Application of Rohail Hada for a Special Land Use Permit (SLUP) to allow fuel pumps in Tier 1 of the Bouldercrest Overlay District and the C-1 (Local Commercial) zoning district, at 2510 Bouldercrest Road.

PETITION NO: N10-2026-1269 SLUP-26-1248268

STAFF ANALYSIS

CASE NO.:	SLUP-26-1248268	**File ID #:** 2026-1269
Address:	2510 Bouldercrest Road, Atlanta, GA 30316	**Commission Districts:** 03 and 06
Parcel ID(s):	15 077 02 011	
Request:	Application of Rohail Hada for a Special Land Use Permit (SLUP) to allow fuel pumps in the C-1 (Local Commercial) zoning district and Tier 1 of the Bouldercrest Overlay District.	
Property Owner(s):	Rohail Hada	
Applicant/Agent:	Rohail Hada	
Acreage:	1.066	
Existing Land Use:	Vacant convenience store and fuel pumps	
Surrounding Properties:	**North:** Forested land, recreational land, and a single-family detached subdivision **East:** Clifton Church Road separates subject site from a shopping plaza **South:** Bouldercrest Road **West**: Bouldercrest Road separates the subject site from multi-family apartment complex	
Adjacent Zoning:	**North:** MZ (Multiple Zoning), R-75 (Residential Medium Lot-75) **East:** NS (Neighborhood Shopping) and C-1 (Loca

CONCEPT PLAN I FOR:
2510 BOULDERCREST ROAD
ATLANTA, GA 30316

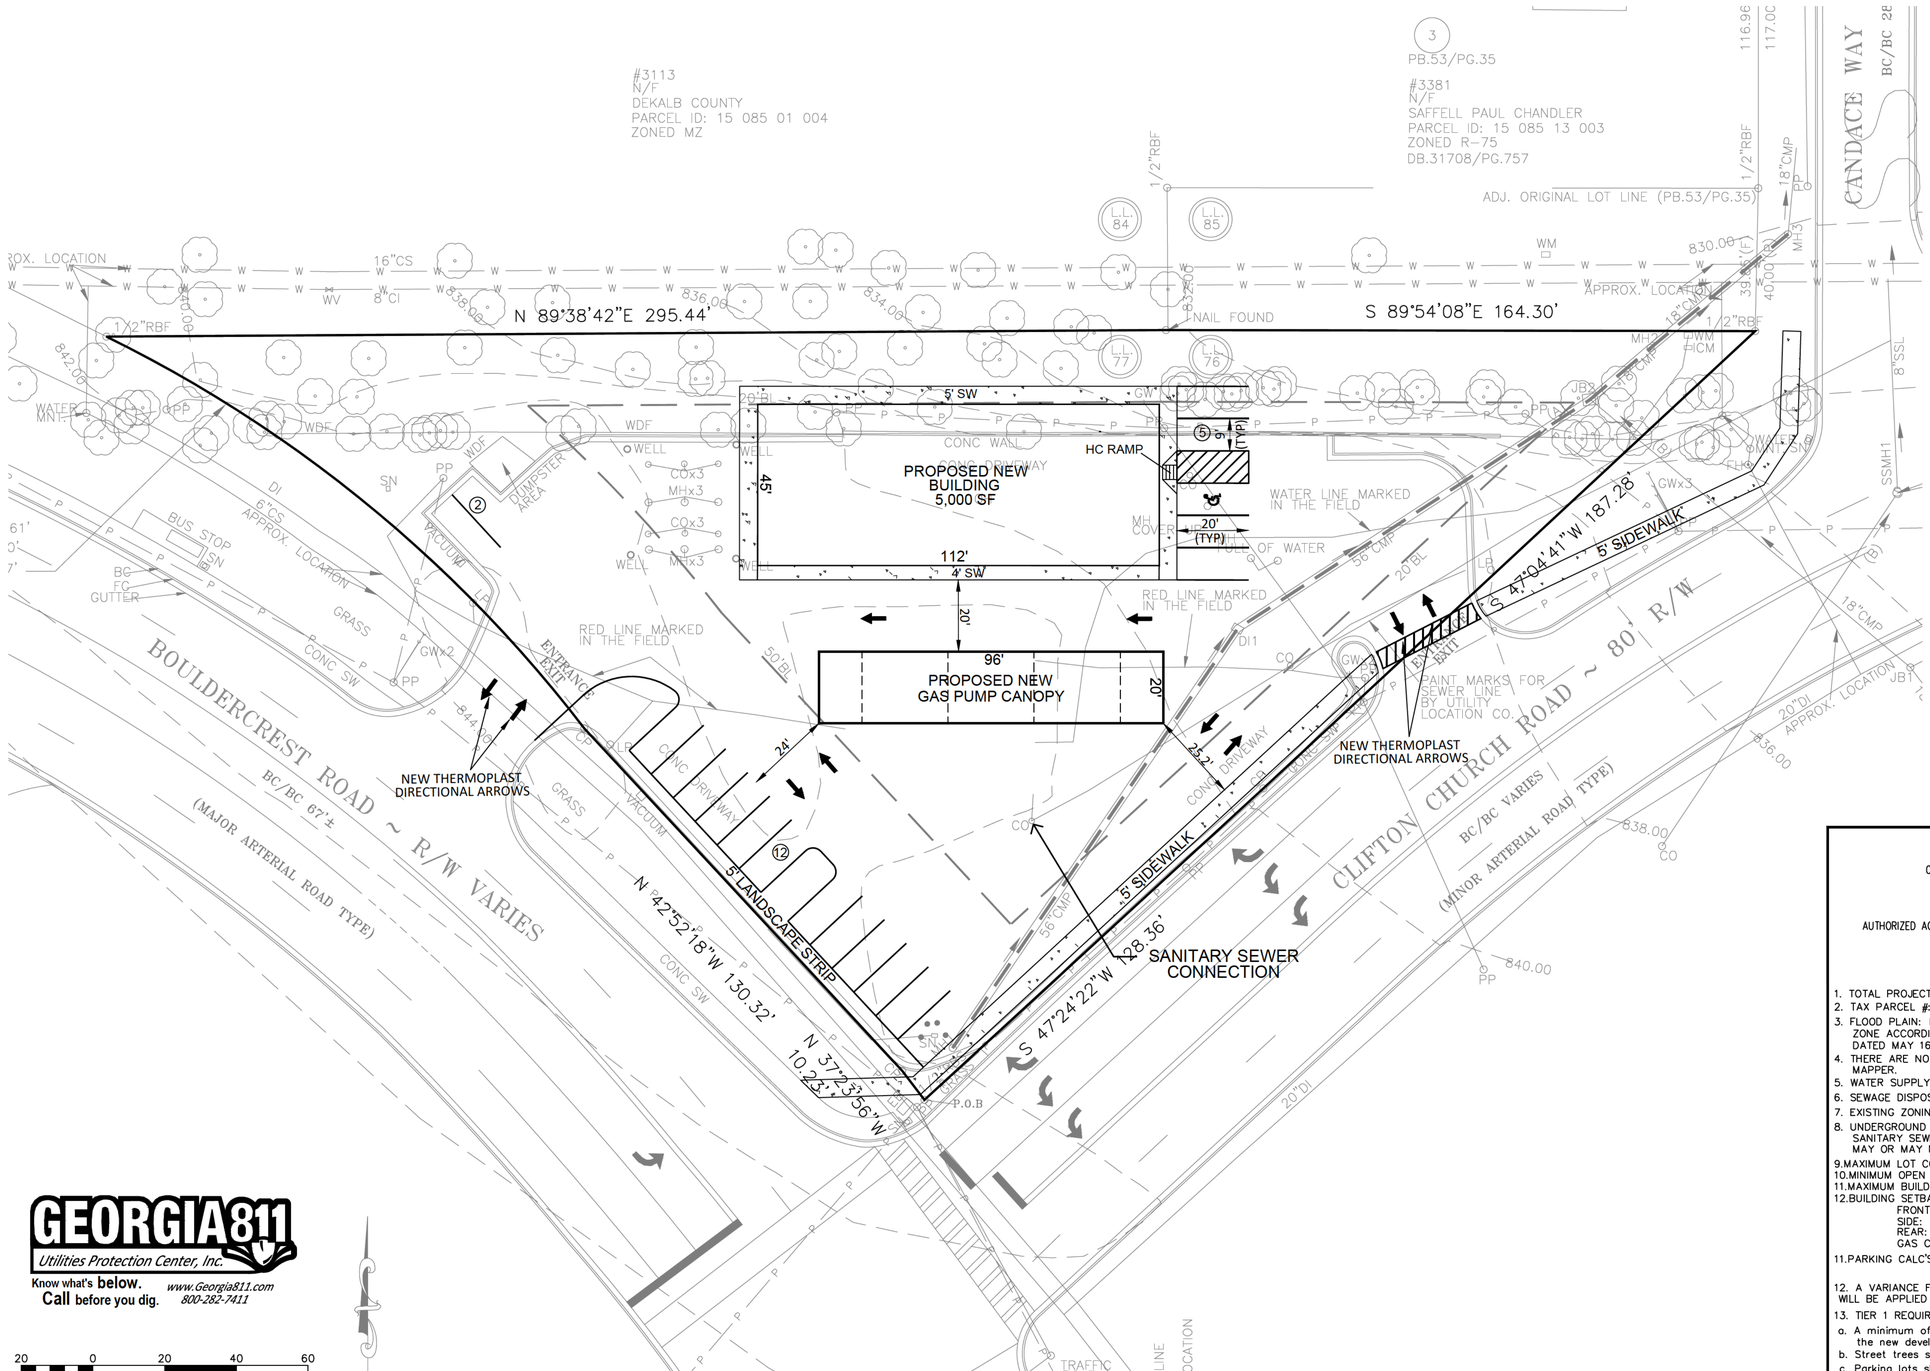
Staff identified several site plan deficiencies related to the Bouldercrest Overlay Standards (Section 3.39.6.- *Standards Applicable to all Tiers*). Subsections C.1 and C.2 require a 10-foot sidewalk, a 10-foot landscape strip, and trees spaced no more than sixty (60) feet apart. Additionally (if not already in place) a right-of-way dedication of seventy-five (75) feet from the centerline of roadway is required - all public infrastructure must be within the right of way. The proposed site plan "*Concept Plan I*" dated, 6/19/2026 shows only a 5-foot sidewalk and 5-foot landscape strip along Clifton Church Road and does not demonstrate compliance with the required tree spacing. Furthermore, convenient pedestrian pathways connecting street sidewalks to each building entrance, are required by Subsection C.4. Any proposed signage must comply with Subsection B and Chapter 21. No additional material concerns were identified by the Interdepartmental comments.

The site's irregular shape and frontage along Bouldercrest Road and Clifton Church Road constrains the buildable area. Compliance with the Bouldercrest Overlay's streetscape, pedestrian access, and right-of-way requirements have not been demonstrated. The proposal appears inconsistent with Supplemental Regulations Section 4.2.28 I., which requires 3,960 feet (three-fourths of a mile) of separation between a new convenience store and an existing small box retail discount store. A Family Dollar is located approximately sixty-five (65) feet away, across the street. The proposal does however appear to satisfy Supplemental Regulations in Section 4.2.8, subject to plan documentation confirming that alcohol sales and storage occupy no more than 20 percent of the gross floor area, as required by Subsection D.

Public services and utilities in the area appear limited. Specifically, District 3 Community Council voted for a deferral for additional community engagement discussions around desired goods and services. The site's proximity is just north of Route 285- an area characterized by warehouses and truck terminals—supporting its functional suitability, with adequate street capacity and good traffic flow. Two (2) access points provide ingress, egress, and emergency access. However, the plan does not show the required safe and direct pedestrian connections from the public sidewalk to building entrances, as required by Section 3.39.6 Subsection C.4.
